Soane Point,  
3-10 Market Place,  
Reading  
**Planning Gateway One**  
**Fire Statement**

23<sup>rd</sup> September 2022

BB-FST-11064-OF-0B

Drawing Title  
Proposed Basement Plan  
PLANNING

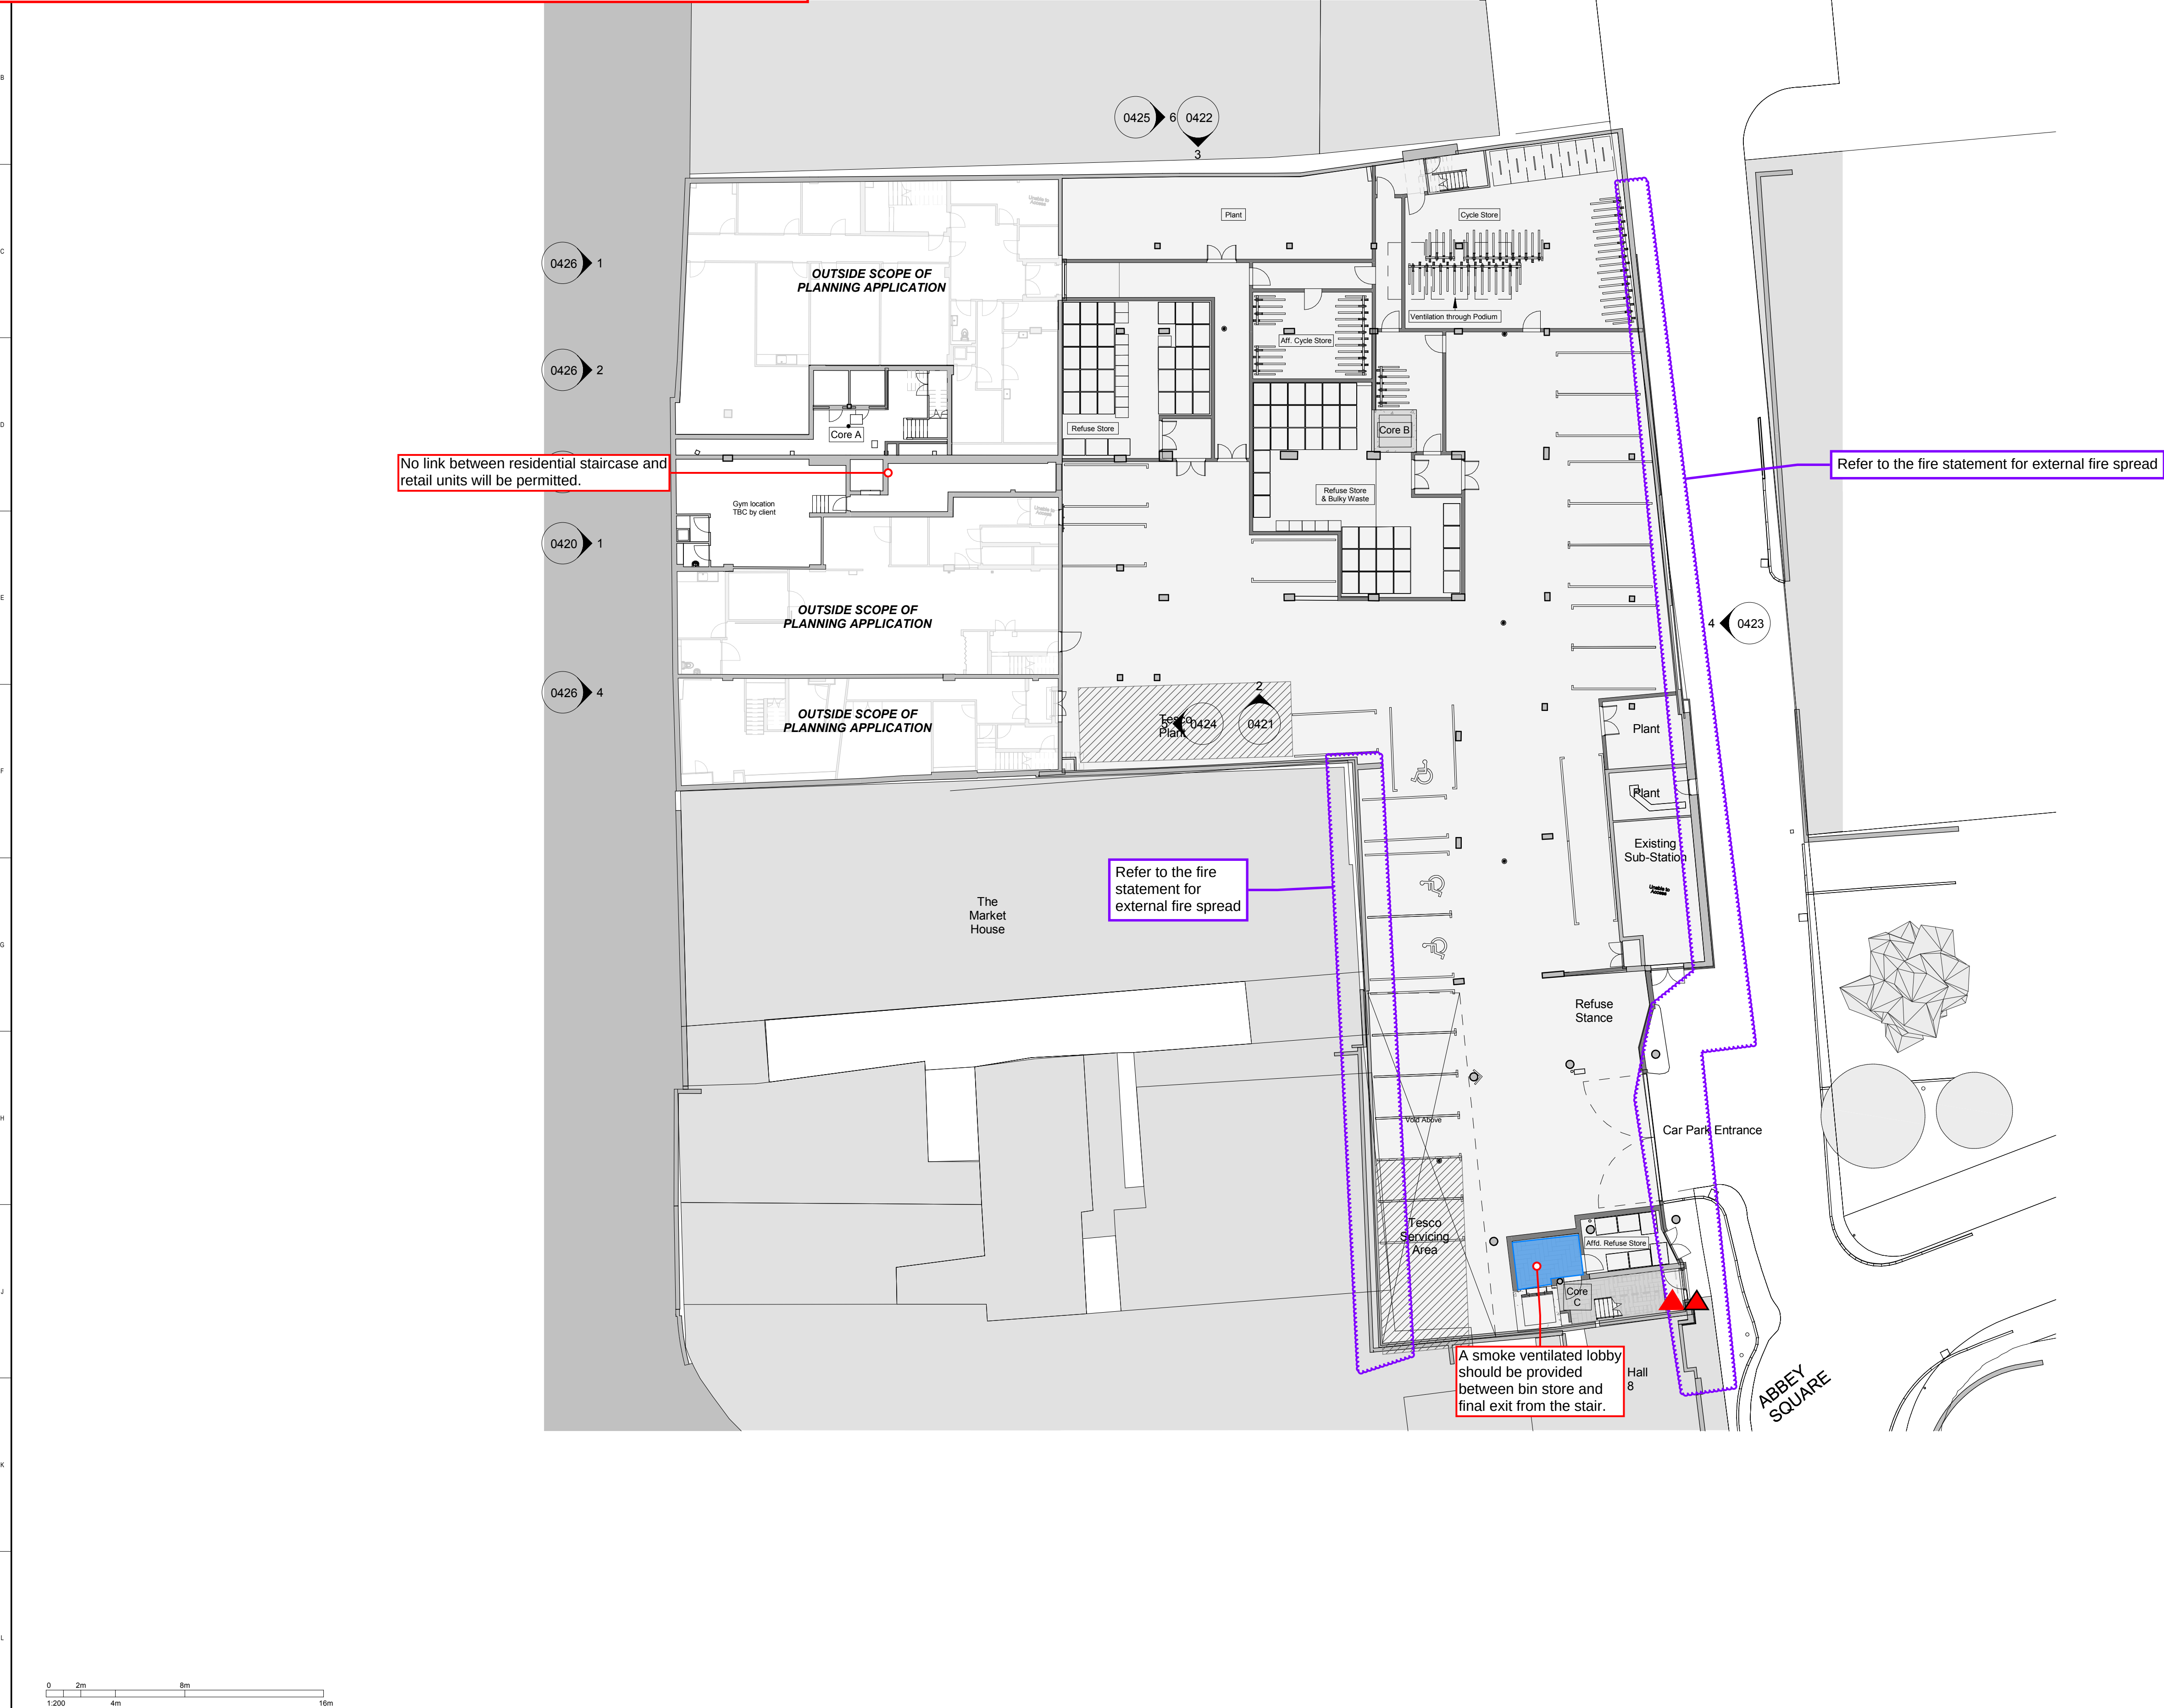
In accordance with BS 9991:2015. If all apartments are provided with sprinkler protection, single direction travel distance can be up to 15m and 60m where there are alternative directions of escape.

Where these distances are extended an alternative engineered solution will be required to be proposed and Computational Fluid Dynamics analysis will be required to be undertaken at the detailed design stage to validate the performance of the proposed smoke ventilation system i.e. mechanical ventilation.

**Indicative mechanical smoke shafts, smoke ventilation provisions and cross corridor doors has been highlighted in the mark ups.**

Proposed Ground Floor Plan

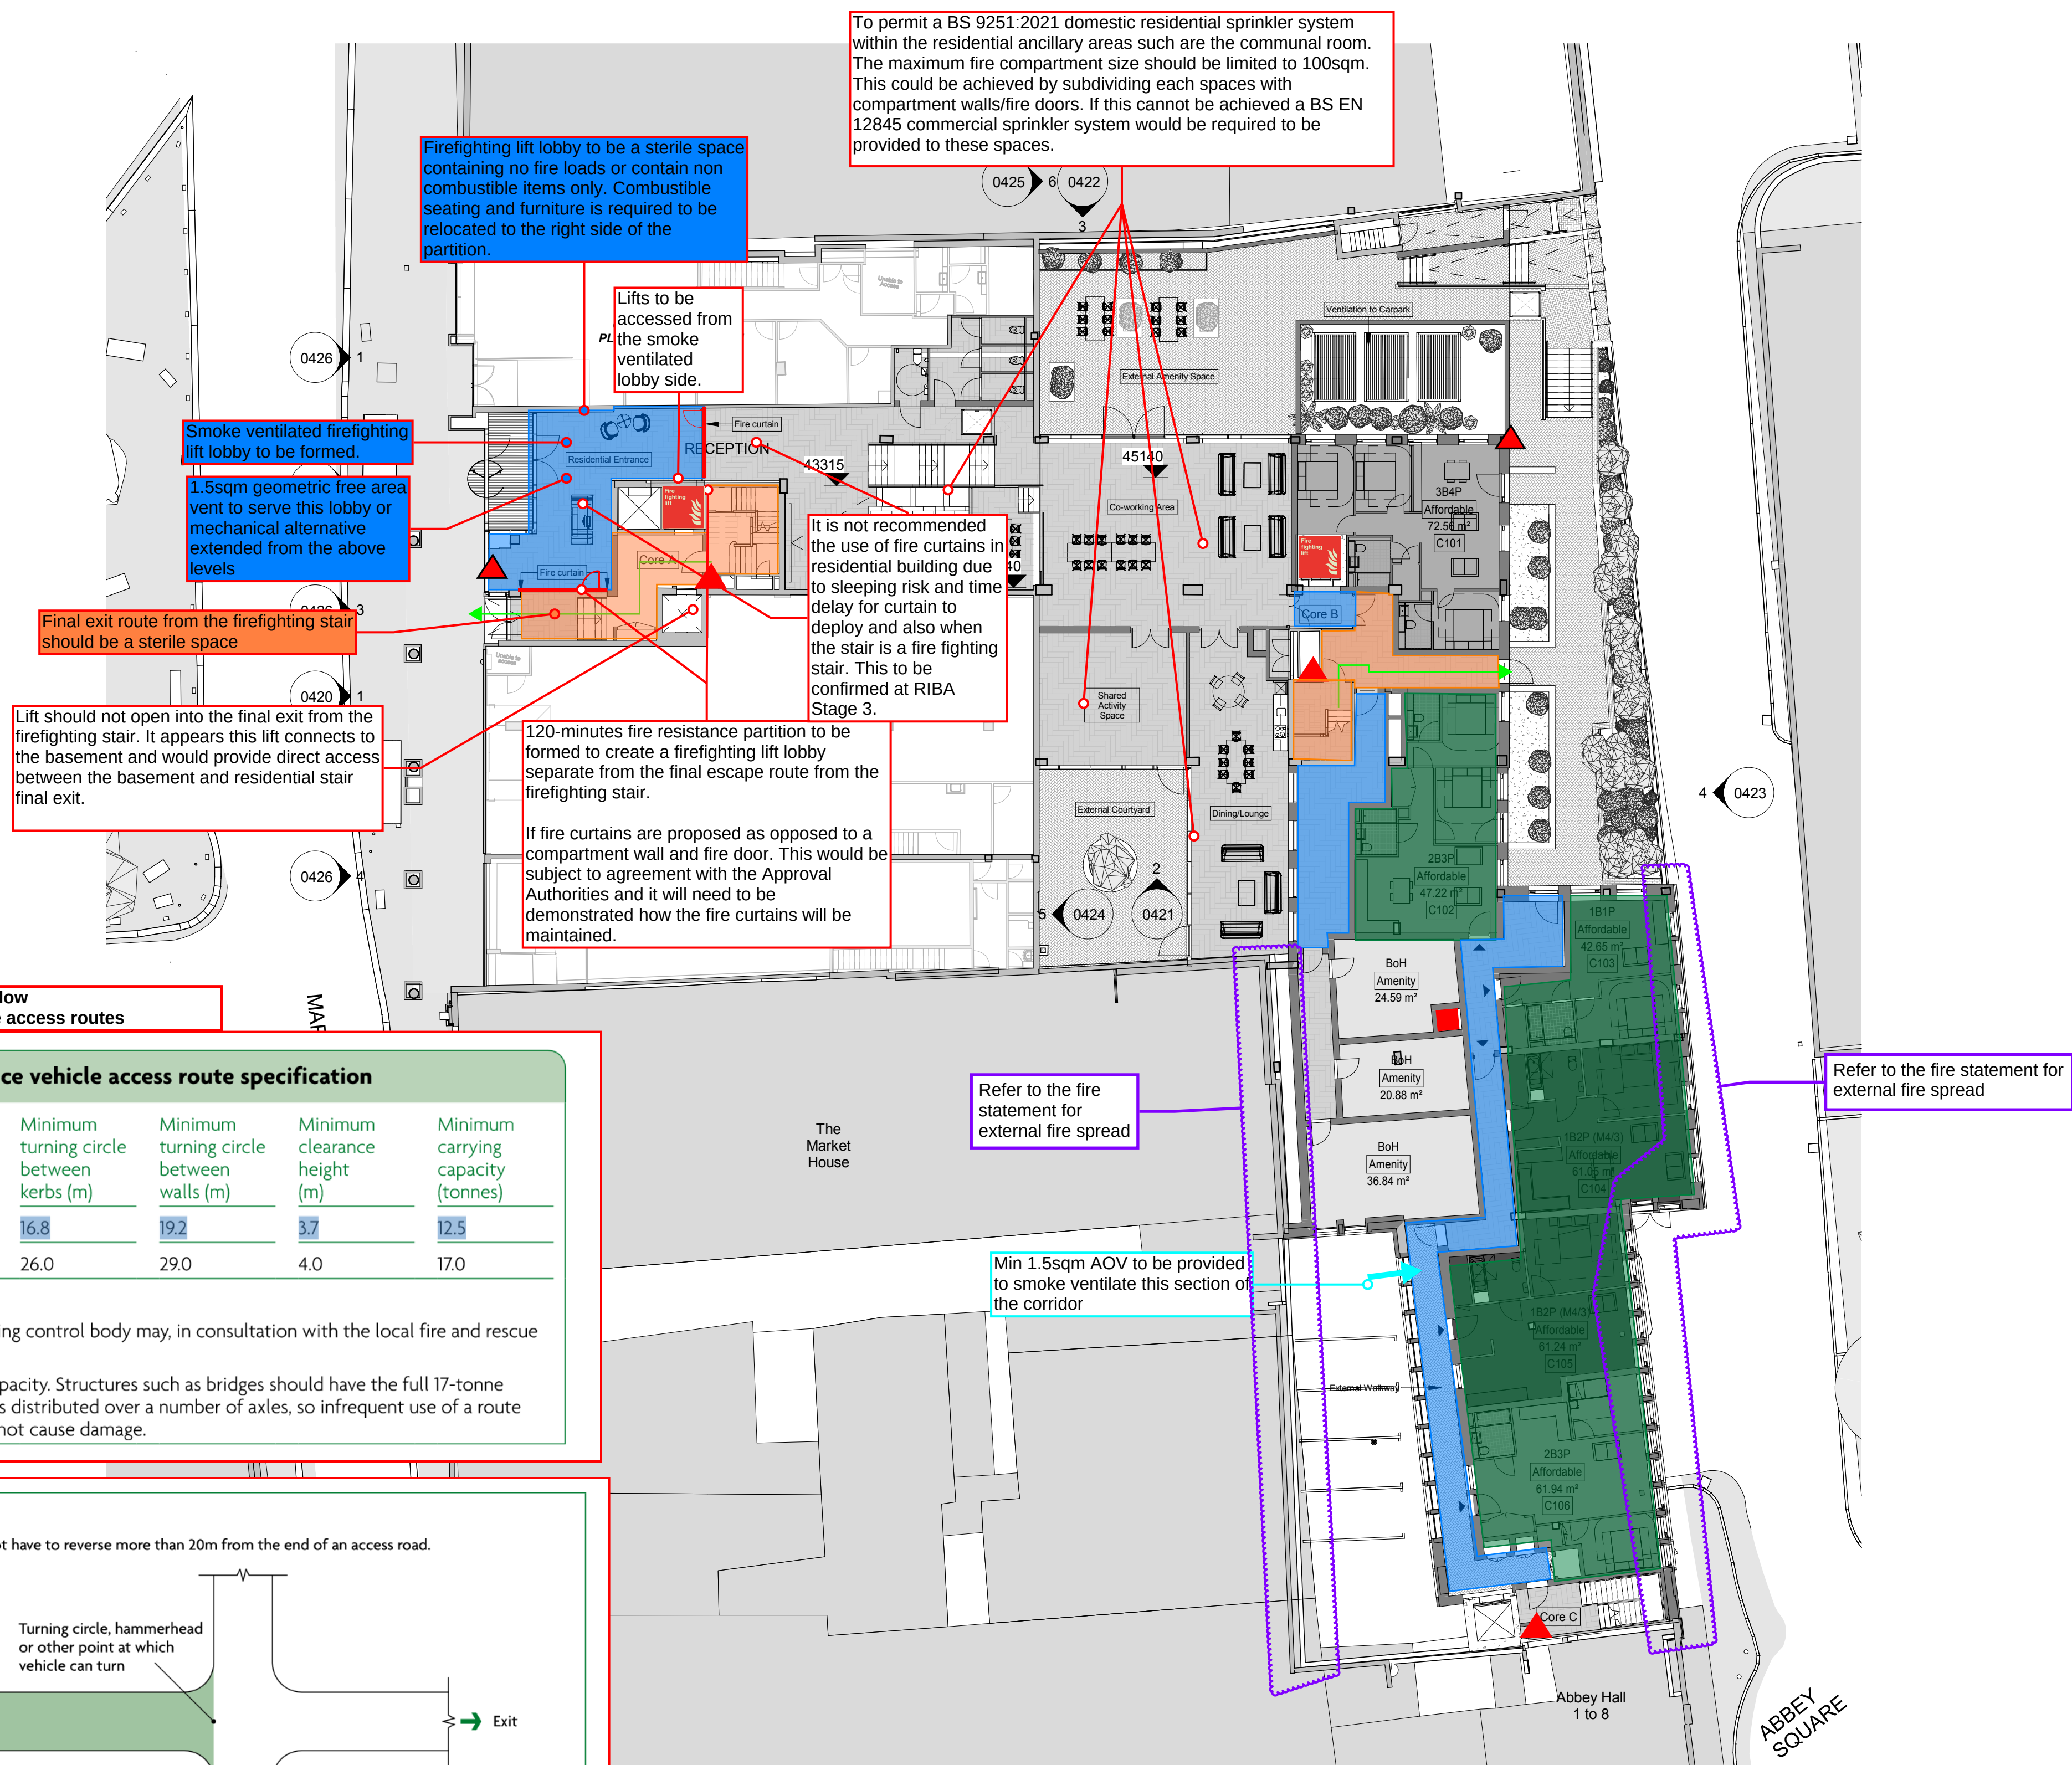
Where these distances are extended an alternative engineered solution will be required to be proposed and Computational Fluid Dynamics analysis will be required to be undertaken at the detailed design stage to validate the performance of the proposed smoke ventilation system i.e. mechanical ventilation.

Indicative mechanical smoke shafts, smoke ventilation provisions and cross corridor doors has been highlighted in the mark ups.

Indicative locations of smoke shafts are shown. The smoke ventilation strategy is to be confirmed and finalised at the next RIBA Stage.

Refer to external fire spread section in the fire statement

Min 1.5sqm AOV to be provided to smoke ventilate this section of the corridor
